PLANT NAME: Monticello

MONTICELLO NUCLEAR GENERATING PLANT
Docket No. 50-263 License No. DPR-22

Response to 8/13/76 NRC Letter on Questions
Concerning Equipment Performance Under
Degraded Grid Voltage Conditions

Generator Real and Reactive Power Operating Limits

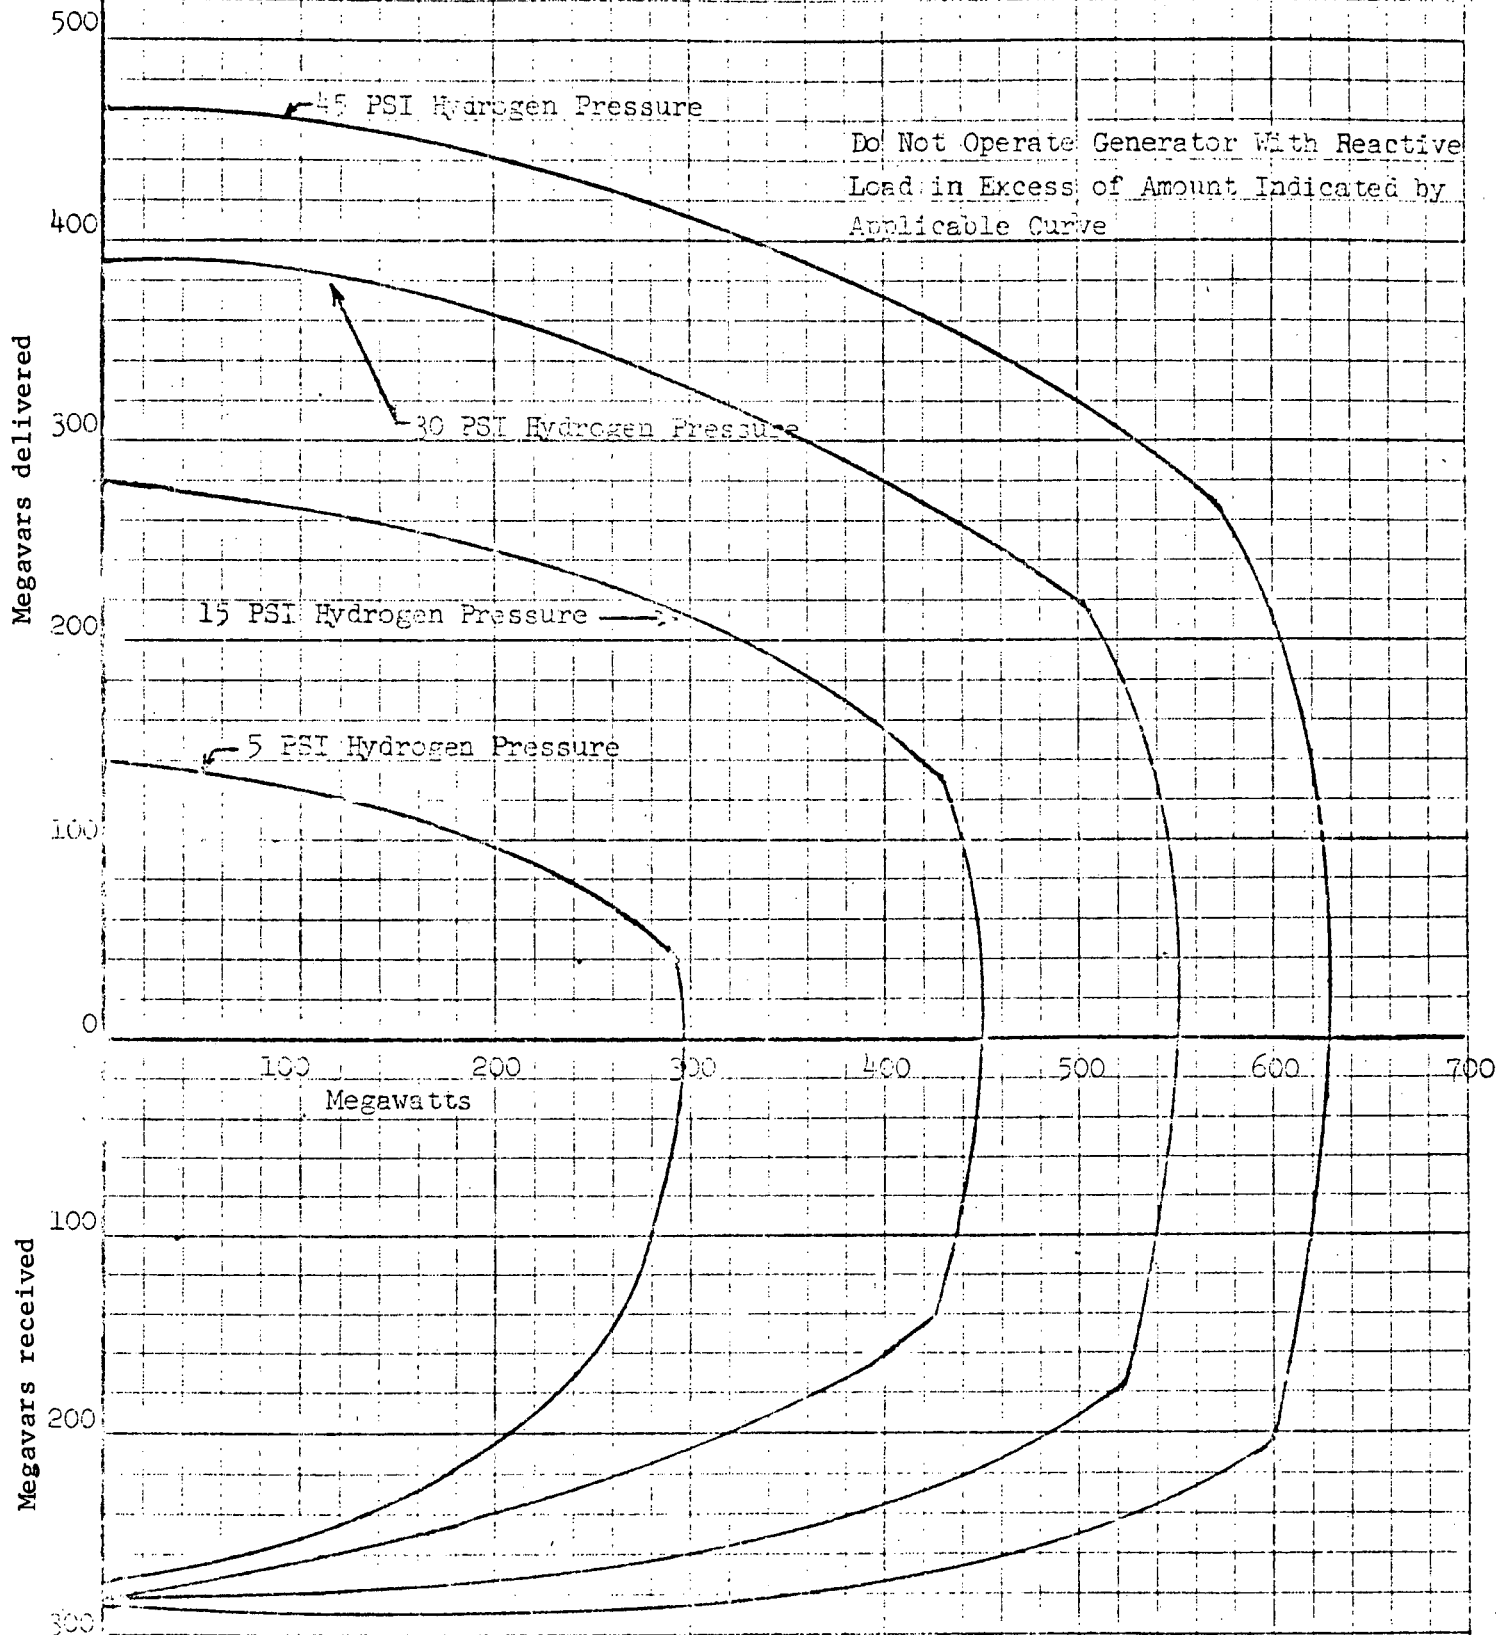
- 1.h. The Operators take a voltage readings of each 4.16 Kv bus (excluding discharge structure buses) every hour from voltage monitors located in the control room. The computer provides an alarm at a high voltage of 4.5 Kv and at a low voltage of 3.8 Kv on any of the 4.16 Kv buses. A trend recorder monitors 345 Kv and 115 Kv bus voltages. An annunciator alarms for loss of voltage in the 345 Kv or 115 Kv Substation. There are also voltage indicators for the main generator, diesel generators and IAR transformer.
2. The load shedding feature is not maintained after the diesel generators are connected to their safety related buses:
3. There is no grid stability analysis cited in the FSAR, however the following operating limits have been established:
- a. Real & reactive power - see attached figure.
 - b. Generator voltage - 22 Kv ± 5%.
 - c. Frequency - underfrequency trip at 58.5 hertz.
